MEMORANDUM

To: The Design Advisory Board
From: Mary O'Neil, AICP, Principal Planner
RE: ZP20-0203CA; 149 Beaumont Avenue
Date: September 10, 2019

Request: 62,250 GSF addition to the existing HSRF building. Addition will be 4 stories and mechanical penthouse. New green space will replace portion of existing parking lot; to include paths, landscaping, benches and lighting

LIGHTING PLAN

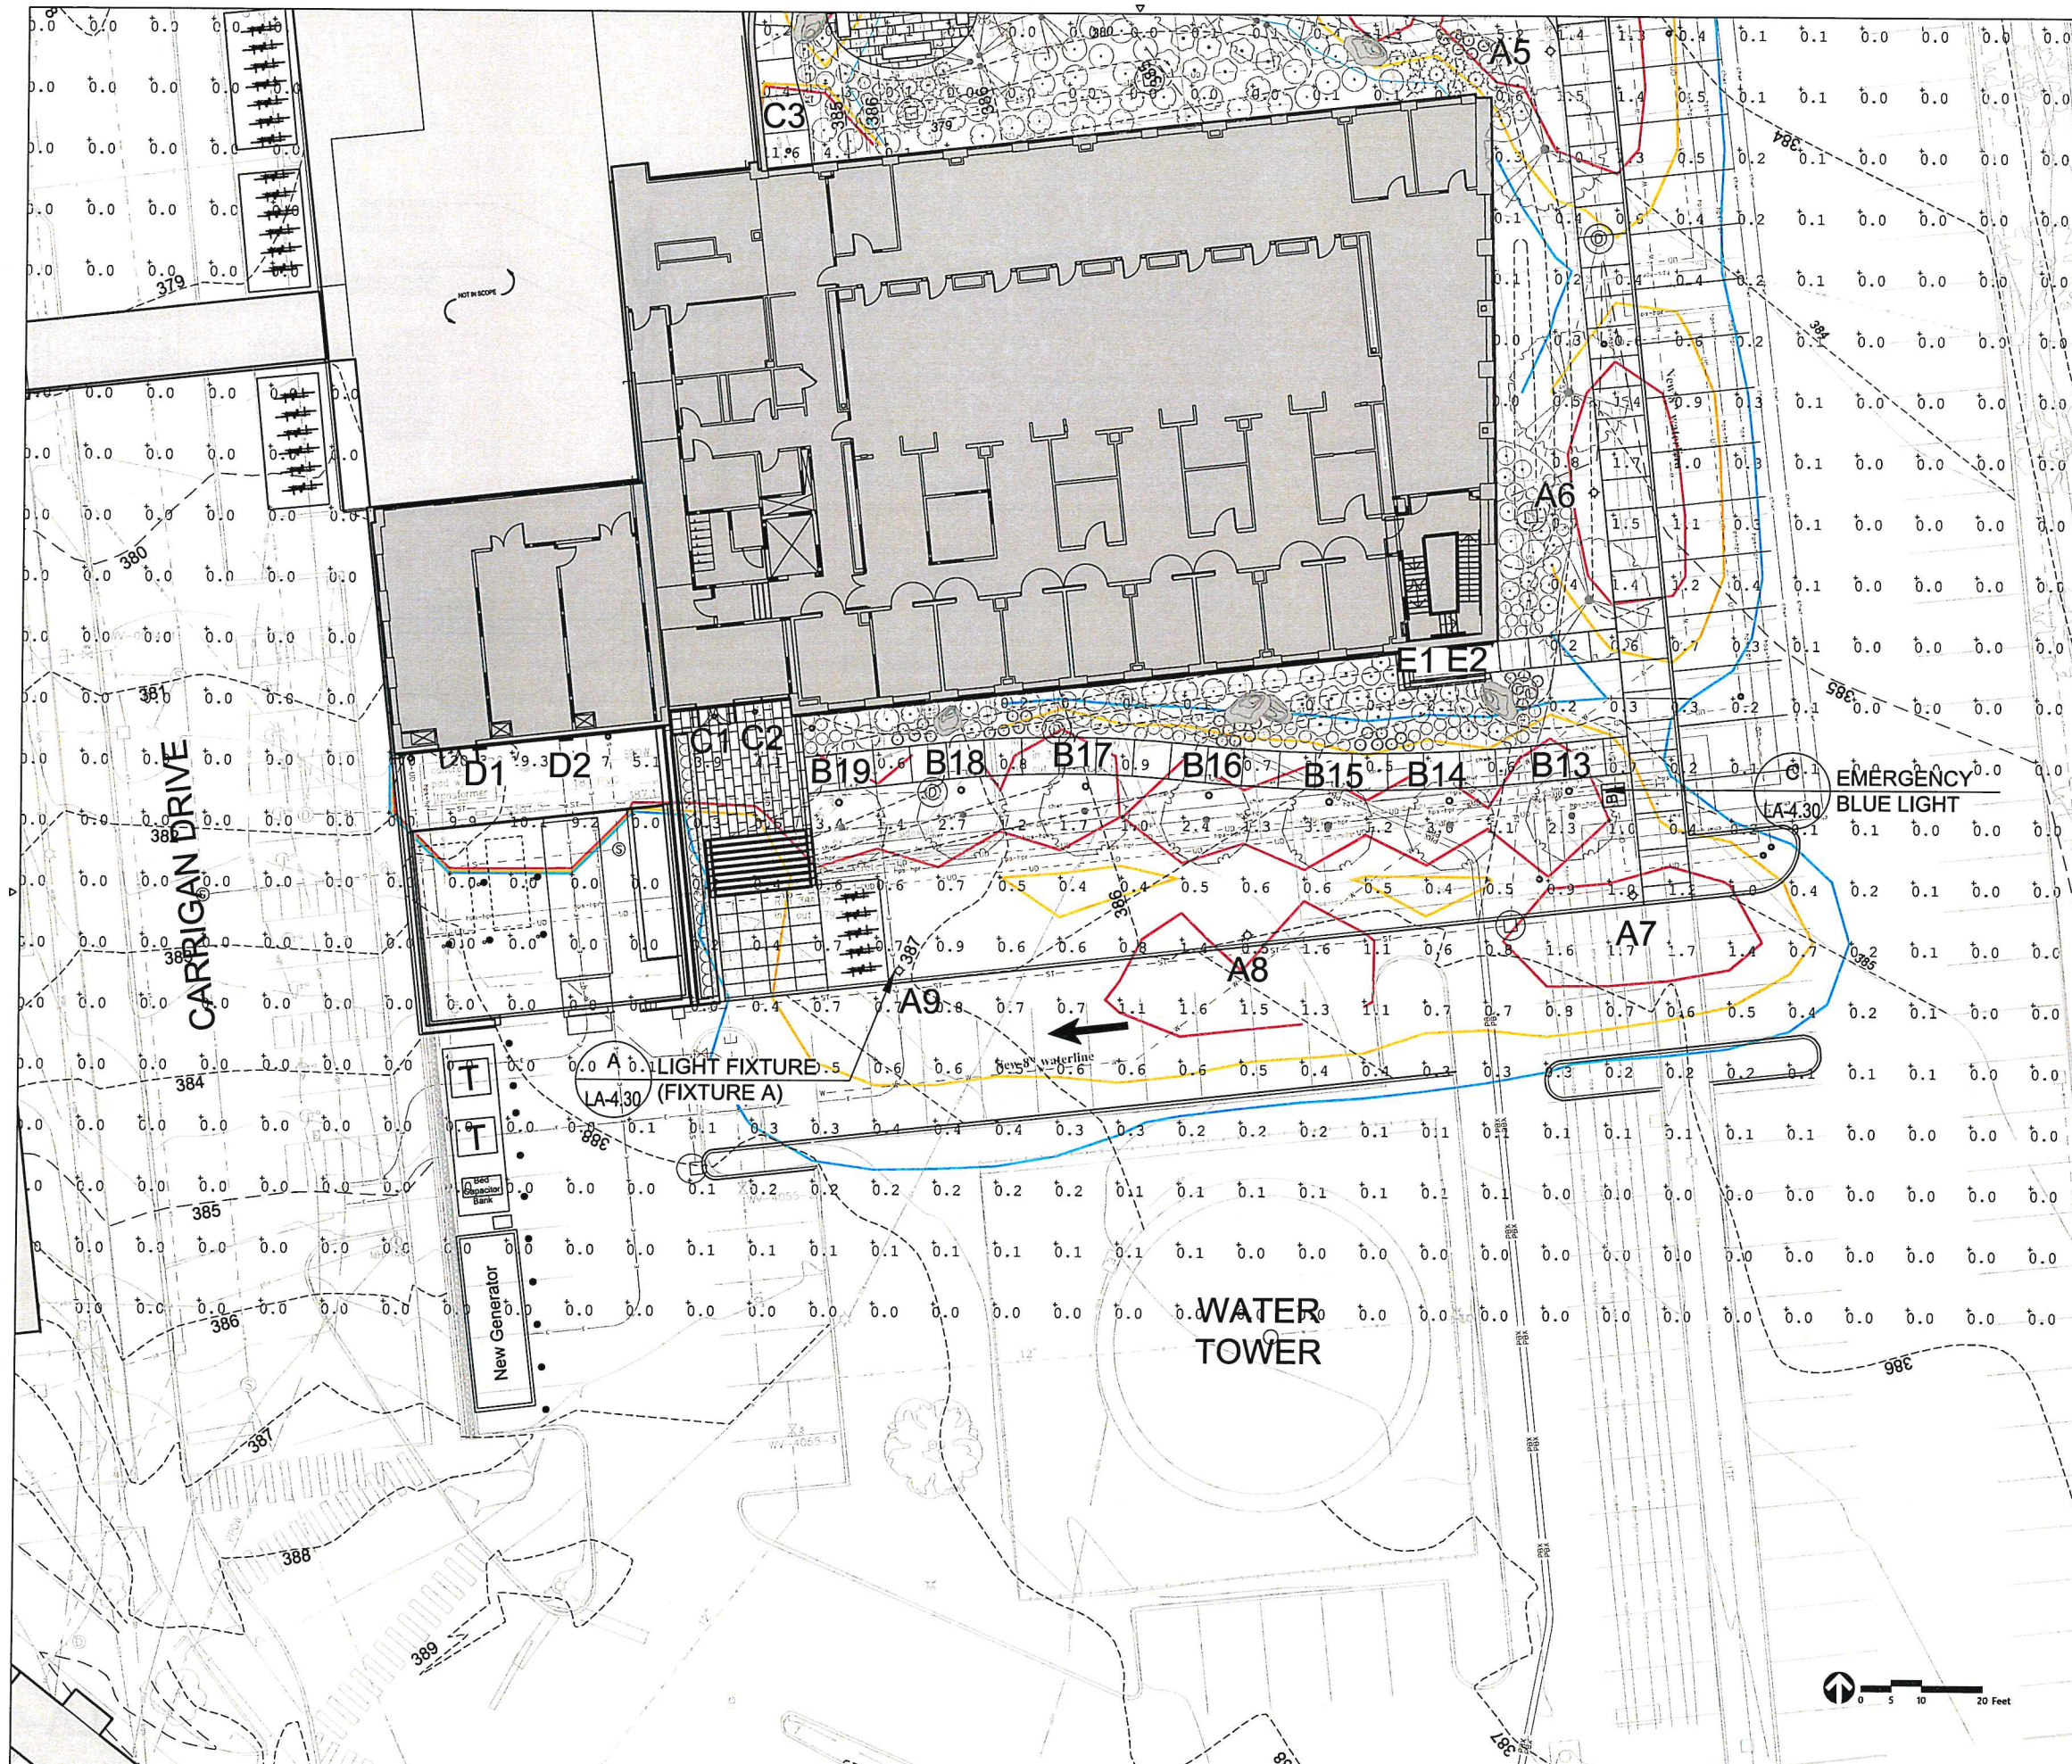
A lighting plan, photometrics and fixture specification sheets have been provided. Sidewalk illumination in a few spots is slightly above the 2.0 fc measurement identified as a maximum for walkways. Additionally, there are “hot spots” around light fixture B8 (7.7 fc) and A5 (5.2) which are extraordinarily high for a pedestrian path. Unless these are identified as egress paths for emergency, the light levels should be modified.

EXTERIOR DETAILS - SKETCHES

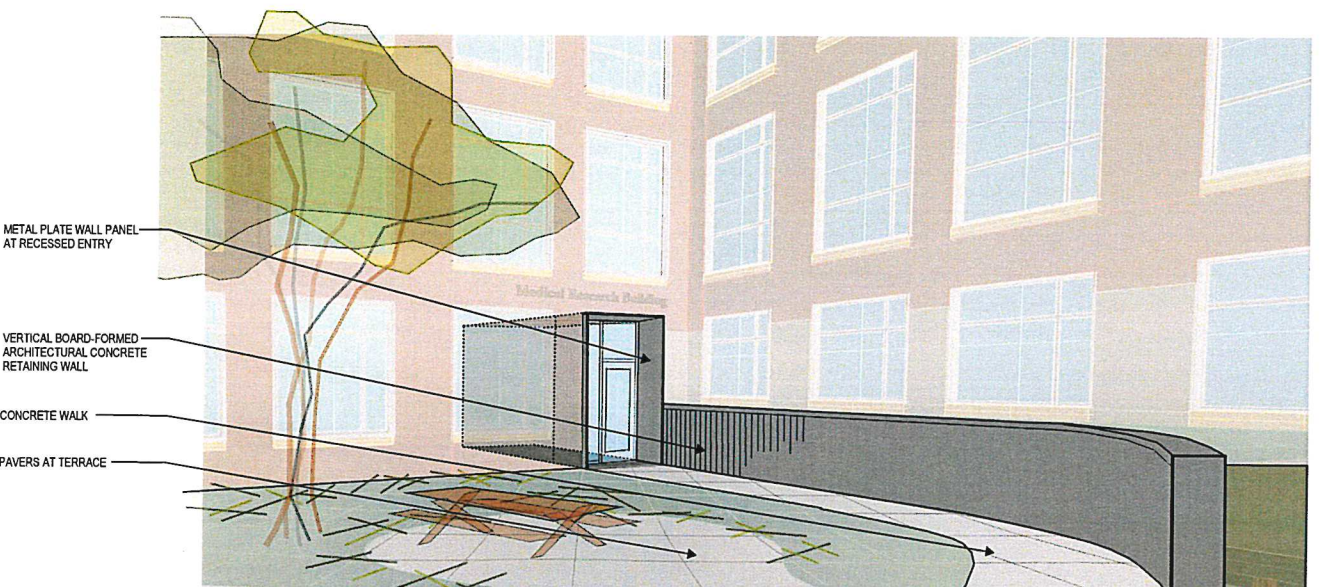
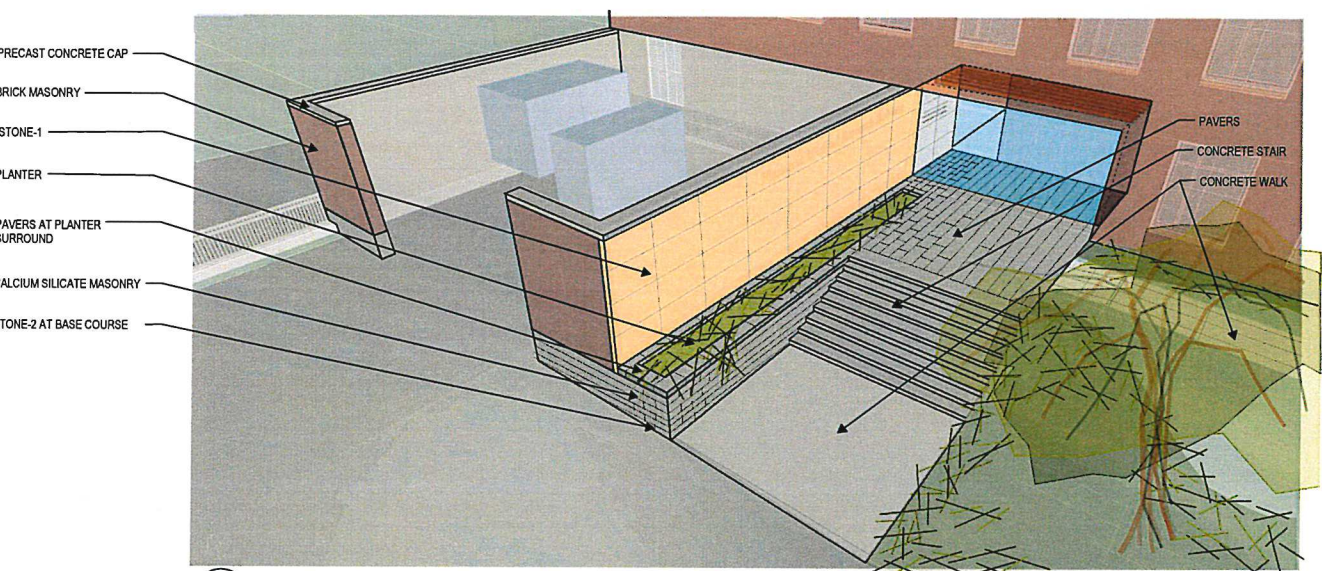
A slightly recessed entry with cover is provided on the north elevation (Plan A8.90). A covered south entry has been graded toward vertical accessibility.
